UNITED STATES PATENT AND TRADEMARK OFFICE

APPLICATION NO.	FILING DATE	FIRST NAMED INVENTOR	ATTORNEY DOCKET NO.	CONFIRMATION NO.
09/801,409	03/08/2001	Gajender Rohilla	CD 00-214	2883

Office Action Summary

DETAILED ACTION

FIG. 4

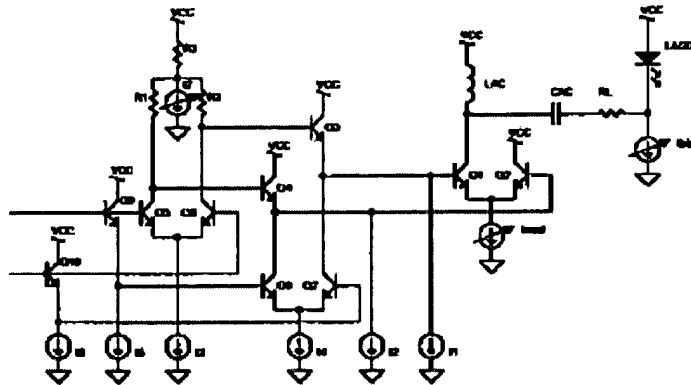
Claims 1-20 are rejected under 35 U.S.C. 102(b) as being anticipated by Link (PN 5,883,910).

Figure 4 illustrates a pair of transistors (Q1,Q2) for driving a semiconductor laser provided with a supply voltage within the range of 3V-5.5V, where the circuit is provided with two current sources I_{bias} and I_{mod}. The transistors each having an input for

purposes of switching and driving the laser, as is well known in the art. In column 4 lines 29-41, disclose the circuit having voltage headroom of 1 volt.
